Cover Page - Addendum No. 7

Architectural Addendum A5

East Hants Aquatic Centre

NOTE: REFERENCE DETAIL 2 / A111

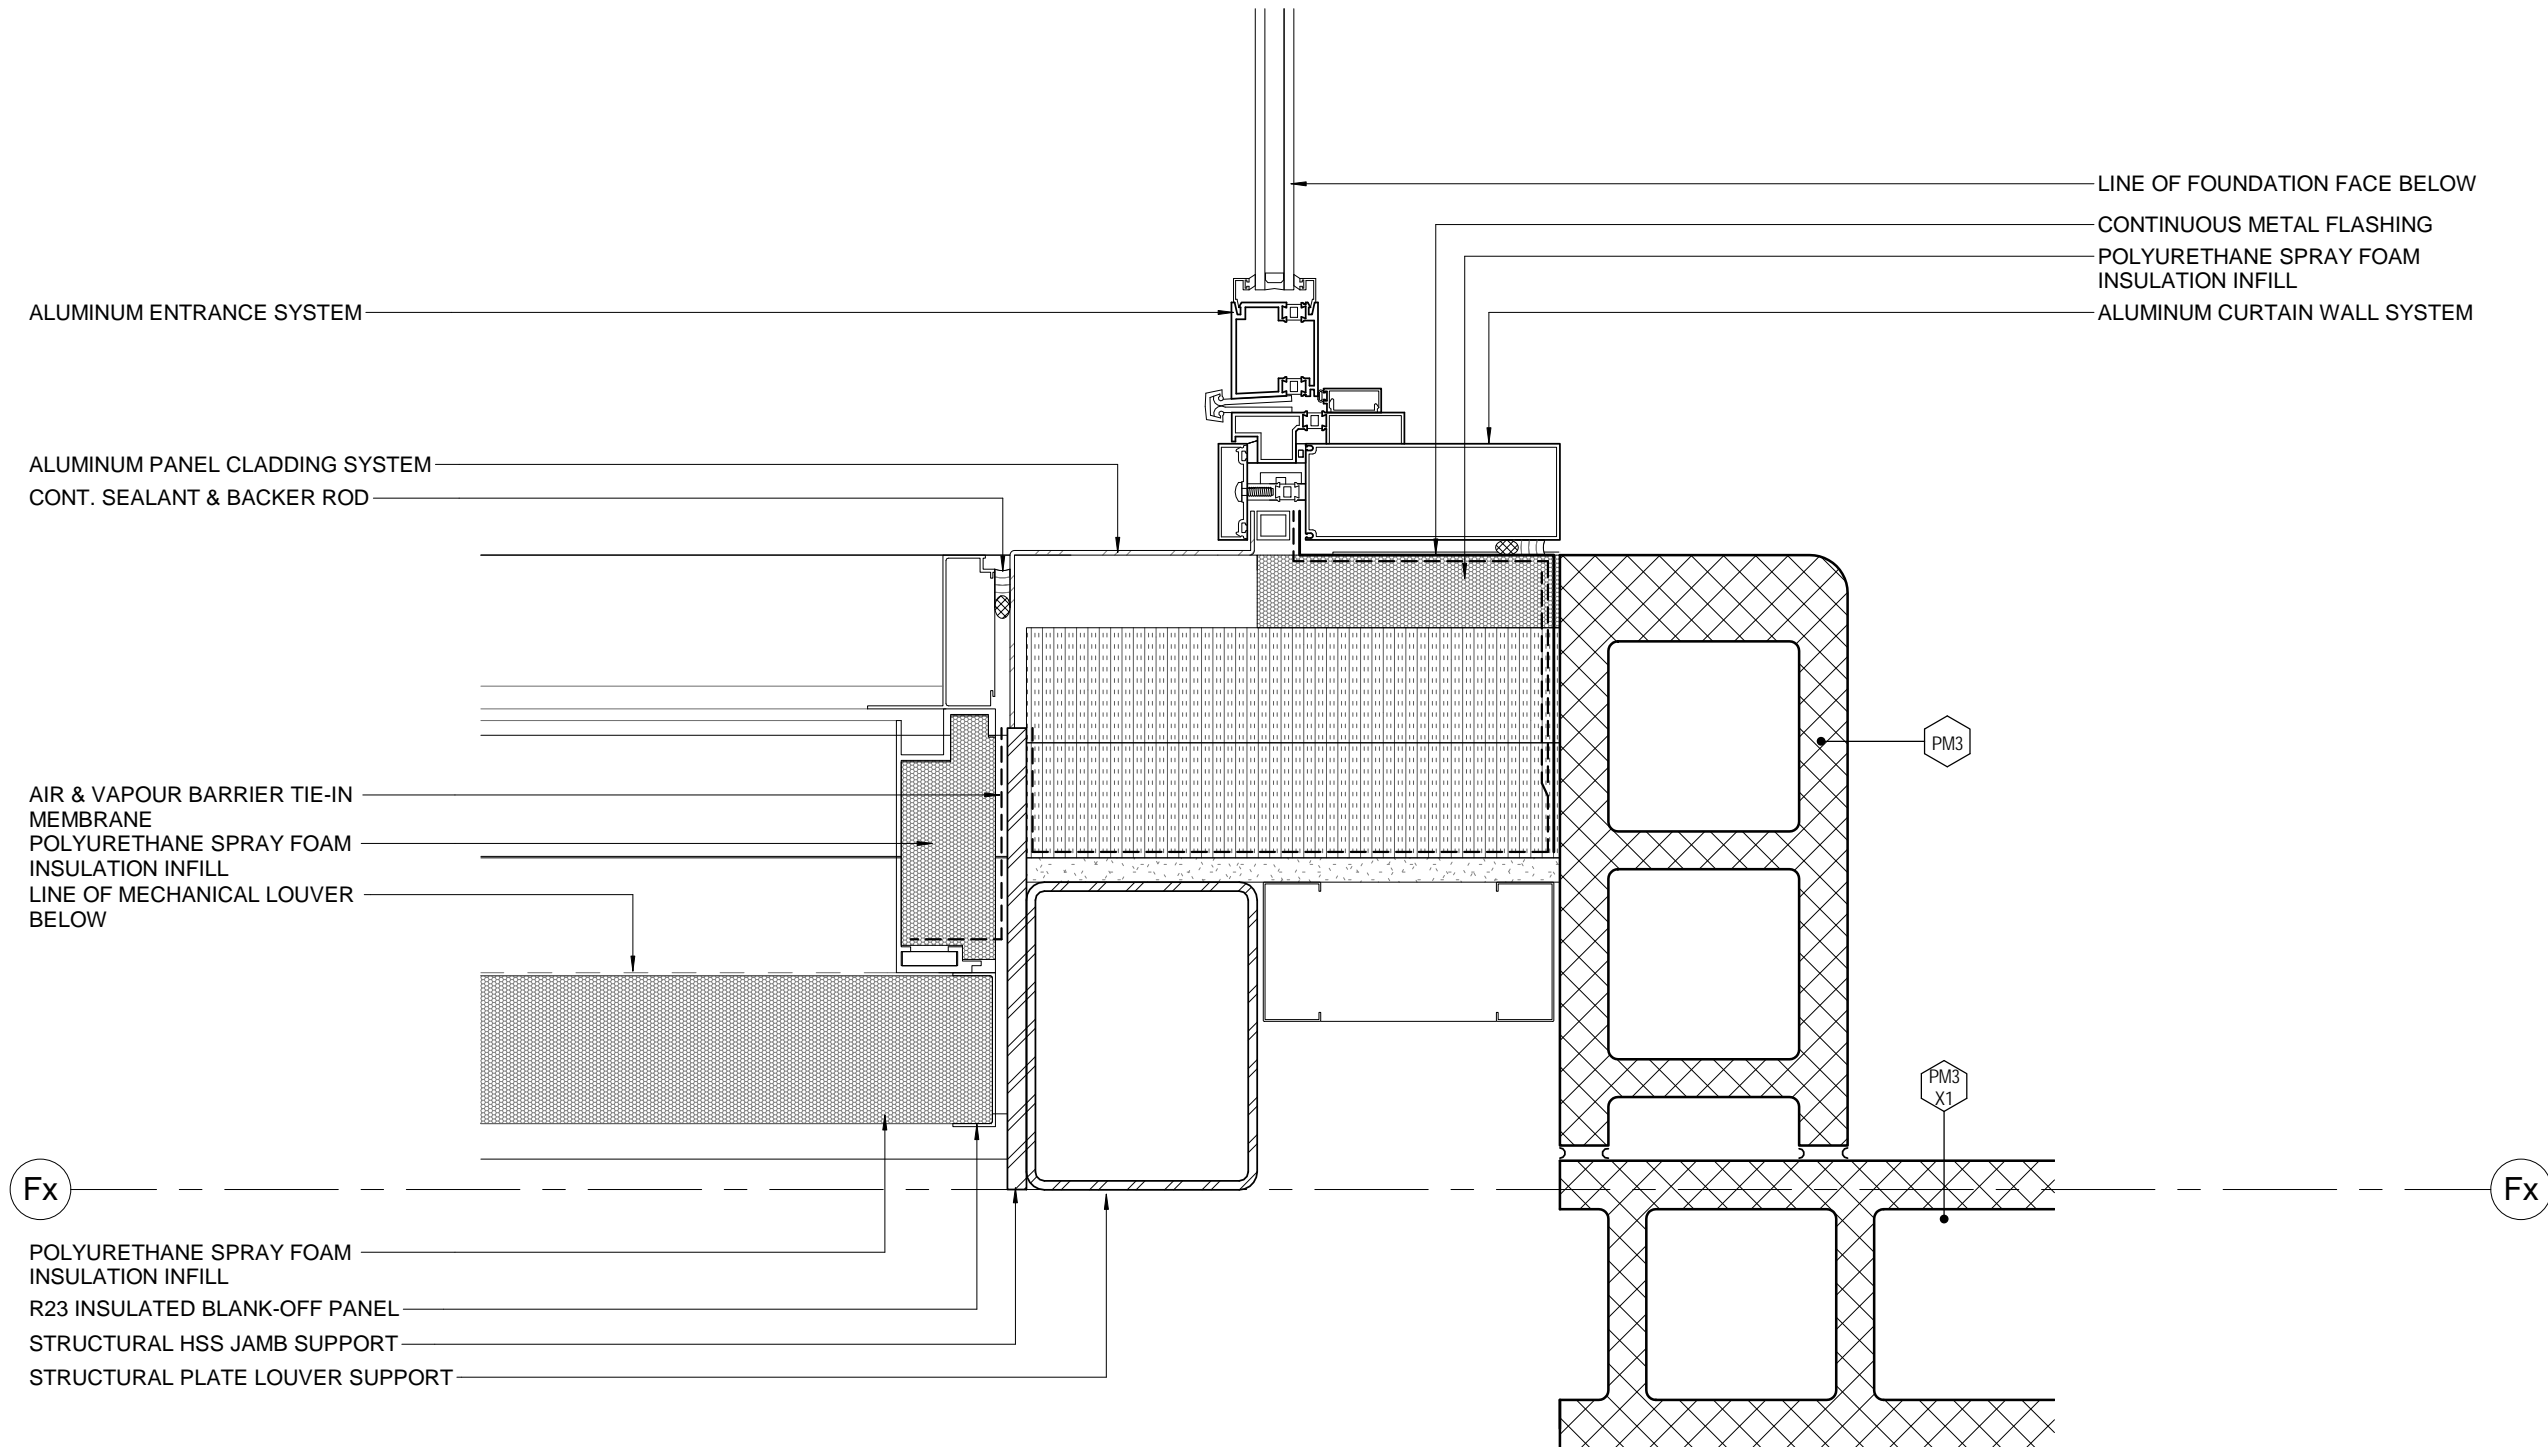
- .1 Revised detail 2/A111 “EXTERIOR WASHROOM DOOR JAMB DETAIL” in accordance with Architectural sketch ASK-002 “EXTERIOR WASHROOM DOOR JAMB DETAIL”, dated 2018-04-04 “Issued for Addendum No.7”.

A710

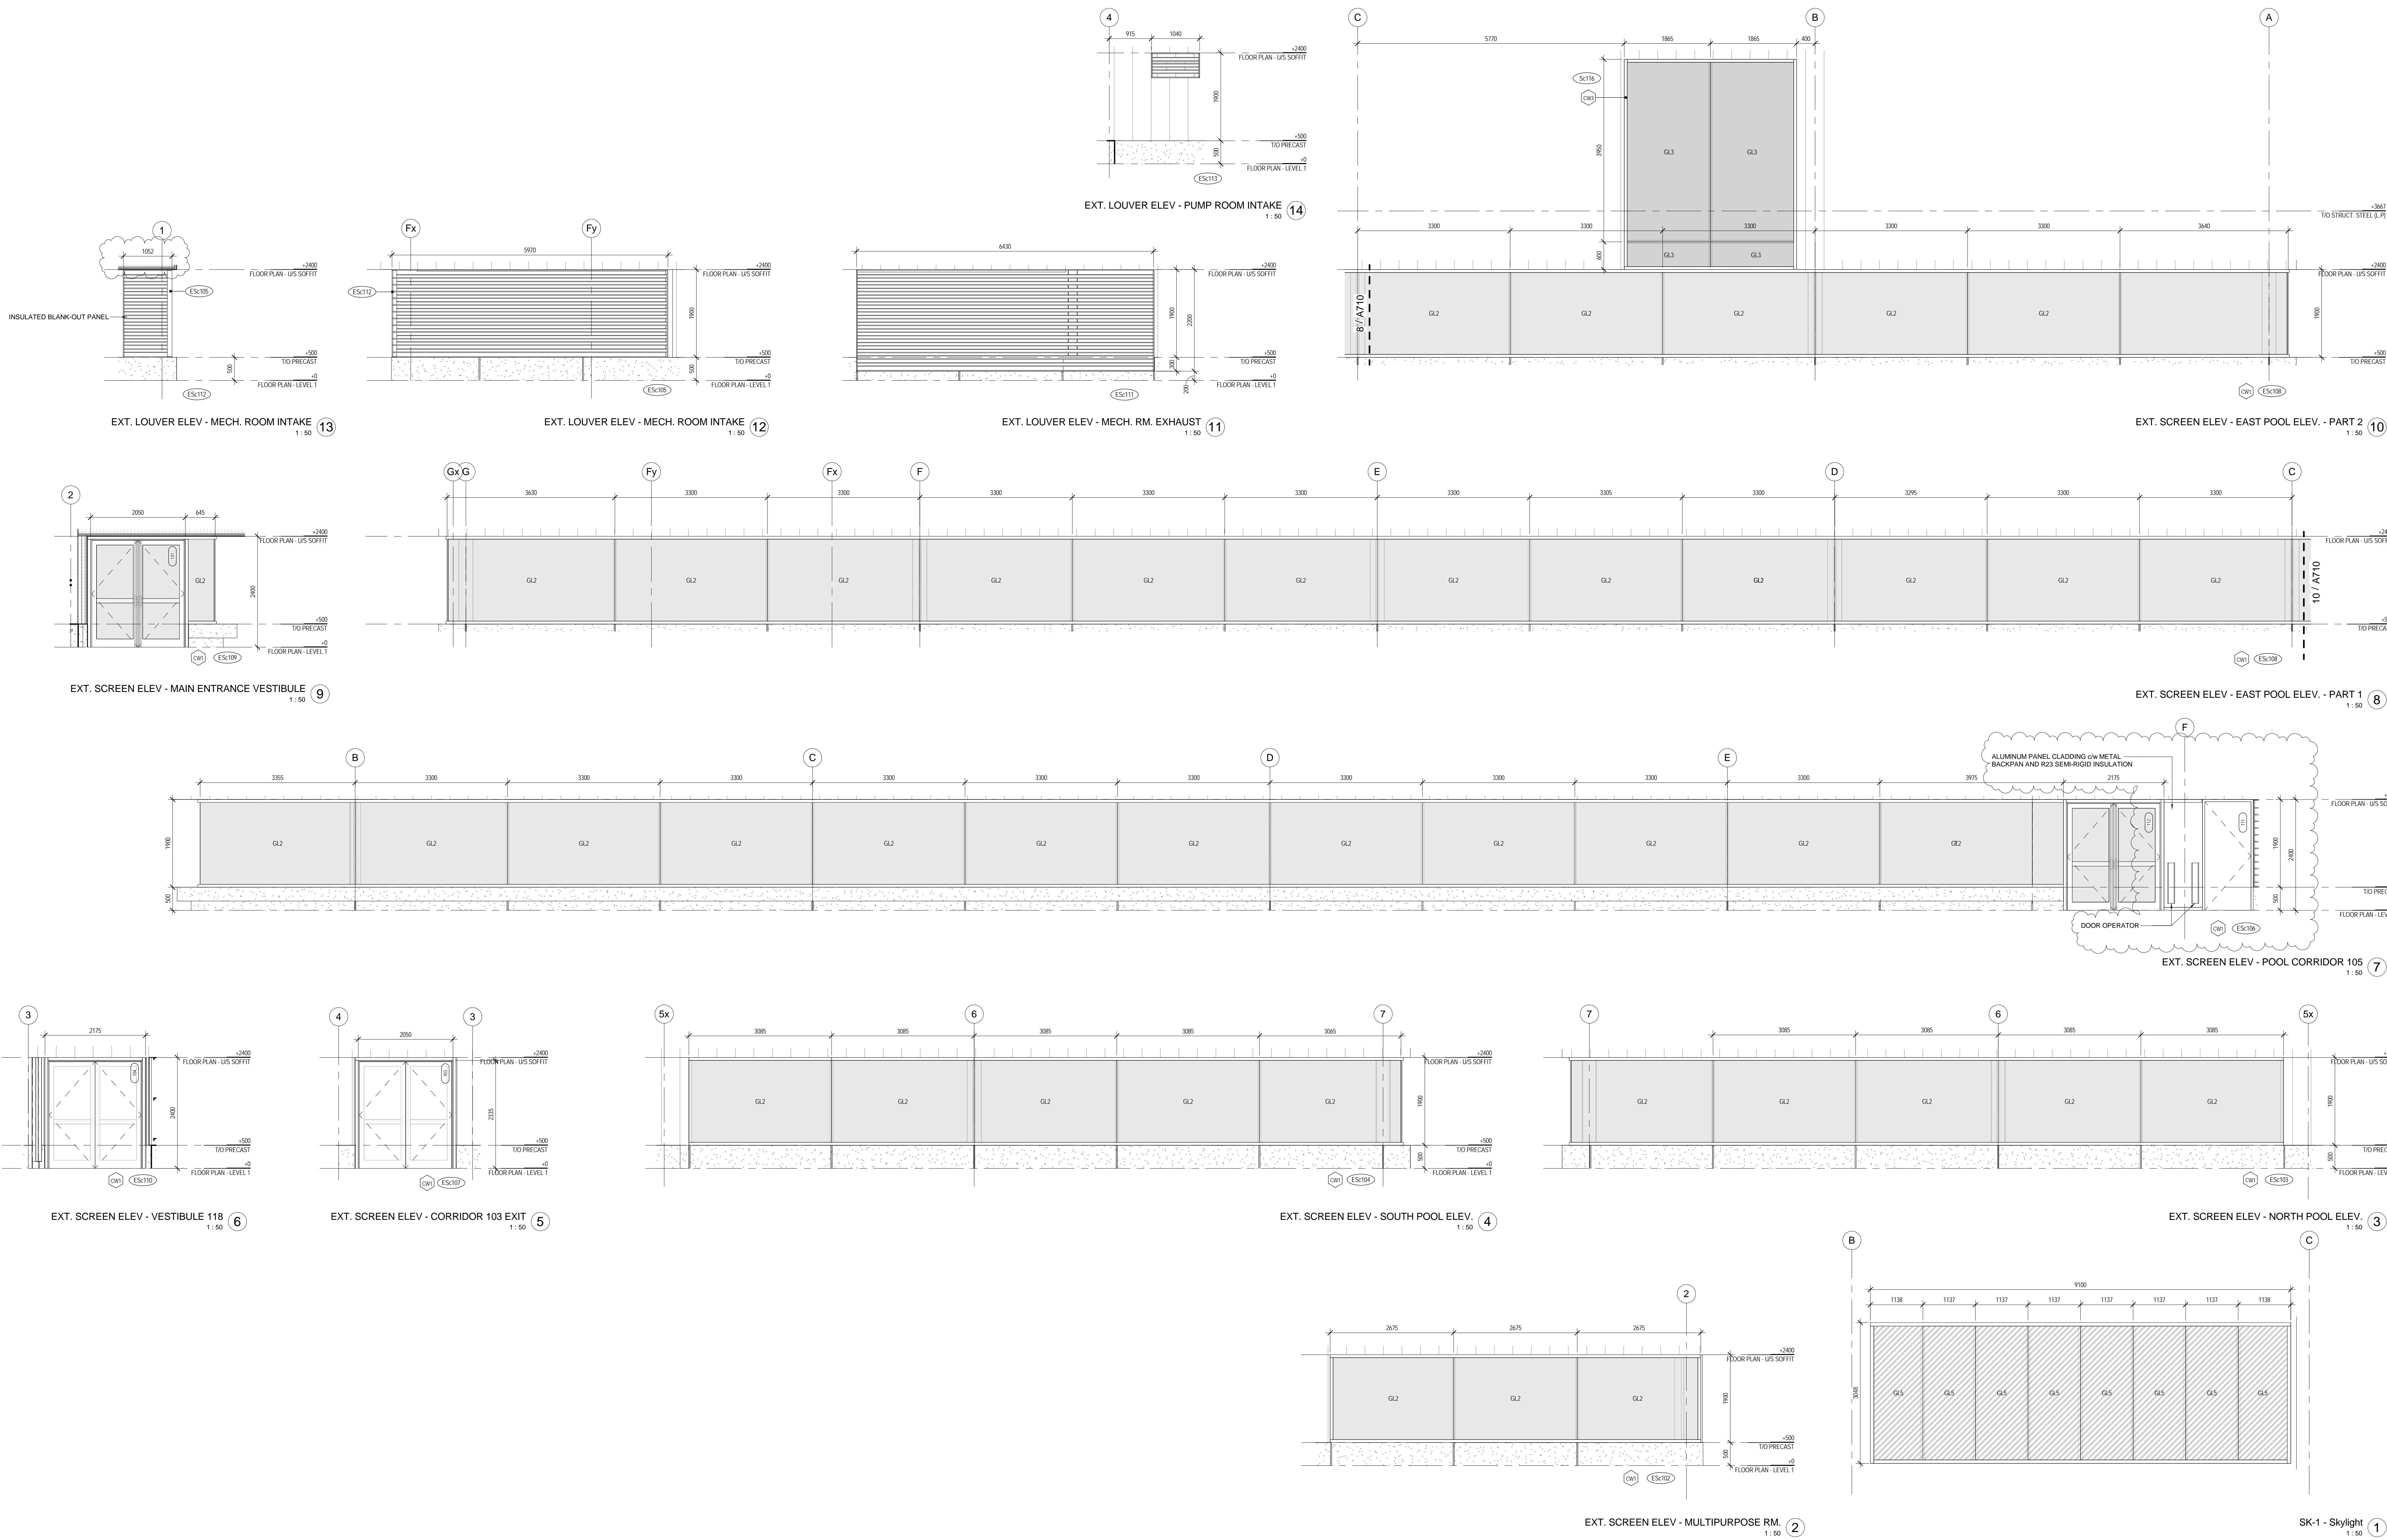
- .1 Drawing A710 “EXTERIOR SCREEN SCHEDULE”, dated 2018-04-04 “Issued for Addendum No.7” to replace and supersede drawing A710 “EXTERIOR SCREEN SCHEDULE”, dated 2018-03-01 “Issued for Tender”. Changes include but are not limited to:
 - .1 Detail 7/A710: Aluminum Glazing System revised
 - .2 Detail 13/A710: Louvre dimension revised.
